**REQUEST FOR EXCEPTION TO
RAPID CITY DESIGN STANDARD AND CRITERIA**

PROJECT 1321 Mt. Rushmore Road
DATE: 10.26.06 SUBMITTED BY: Roger Baker 6 Fairmont Blvd
PIN #: 3702430025 W- 343-9559 H- 716-3765
LEGAL DESCRIPTION: E 114.1' of LOT 21 WEST BOULEVARD.

EXCEPTION REQUESTED: SECTION 8.2.1 STANDARD/CRITERIA STREET CRITERIA MANUAL
DESCRIPTION OF REQUEST: to PAVE RIGHT-OF-WAY FOR PARKING.

1321 Mt. Rushmore Road

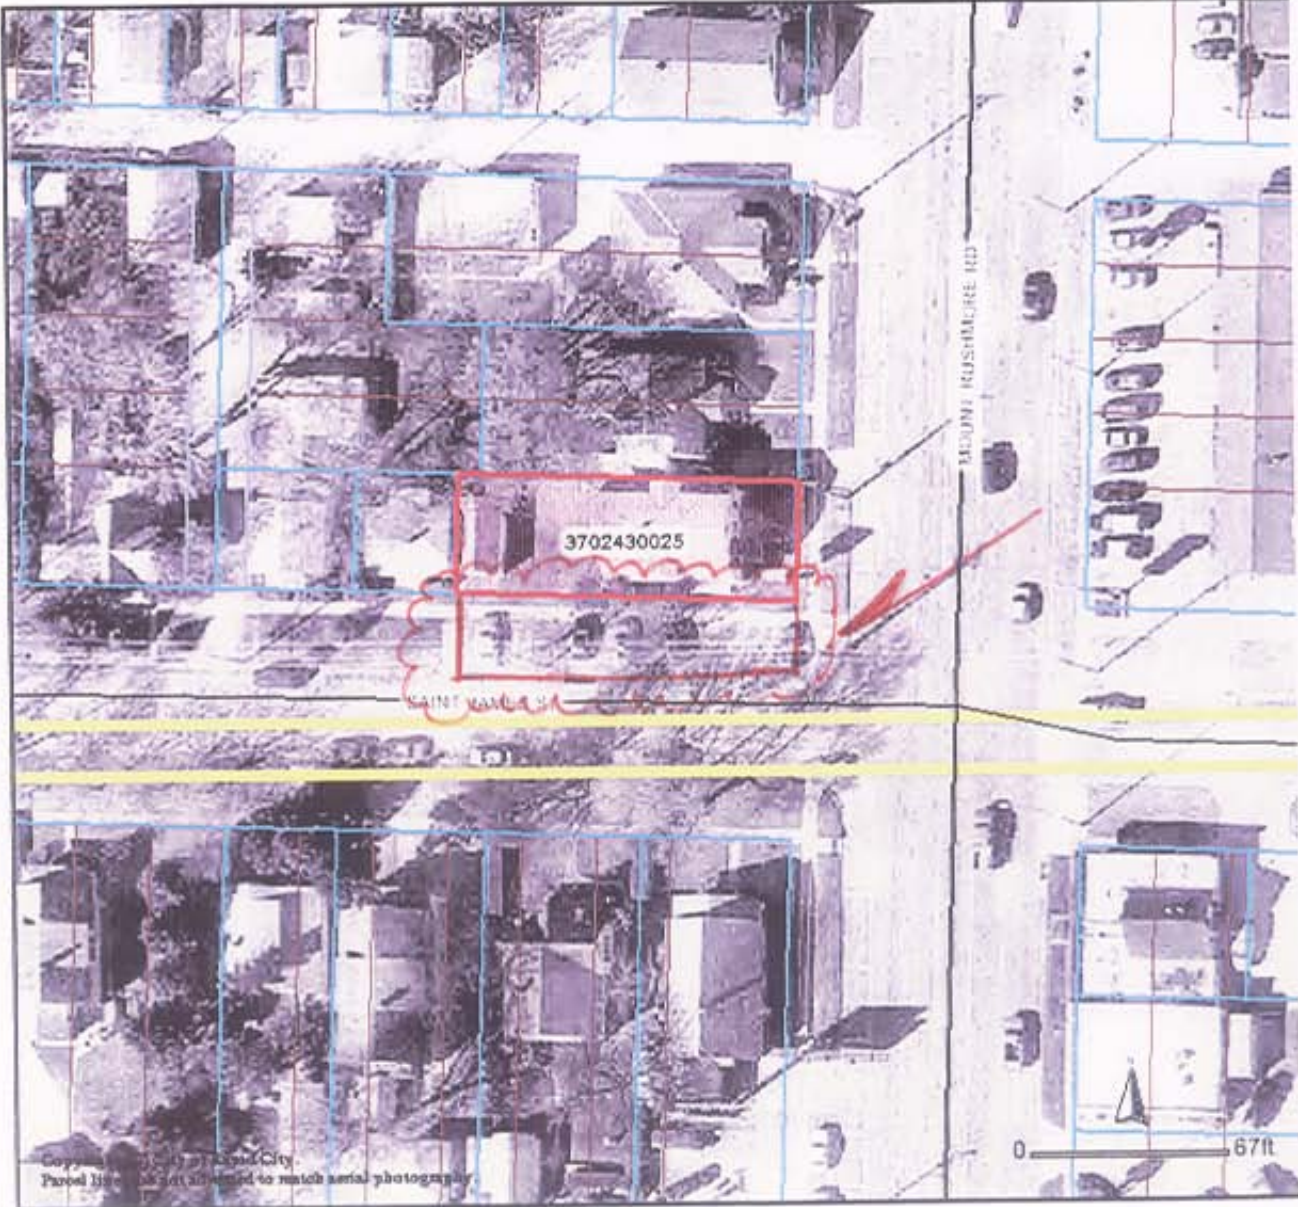
JUSTIFICATION: This has been gravel parking for many years. It would look so much nicer if I could asphalt it.

STAFF RECOMMENDATION: To deny as it violates 8.2.1 G of The Street design criteria manual

Sheldon Vore Deny 10-26-06
for PUBLIC WORKS DIRECTOR DATE
10.30.06 - CALLED ROGER - WANTS TO PUT ON PW 10:30AM AGENDA - BRINGING PICTURES. LUC
